Access Compliance Report

Public Rights-of-Way

Intersection ID: 11567	Main Street: SHAMROCK_DR	Cross Street: TIPPERARY_PL	Location: NW
ADA ID: E6A0998827EA	Ramp Type: PerpDiag	Initial Pass/Fail: Pass	Overall Compliance: No
		Severity Score: 35

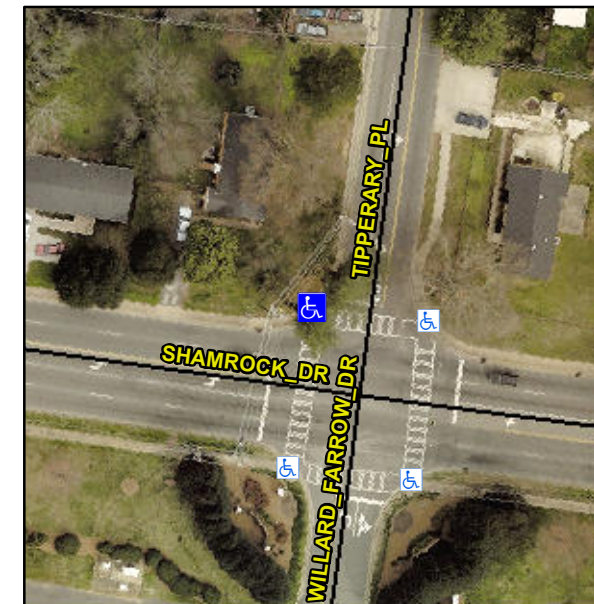
Not Found, R304.2.1, R304.2.2-Perp, R304.3.2-Para, R304.5.3, R304.2.3, R302.7.2, R304.5.4

Remove & Replace Curb Ramp With Two New Directional Ramps or Equivalent. Remove & Replace Gutter.
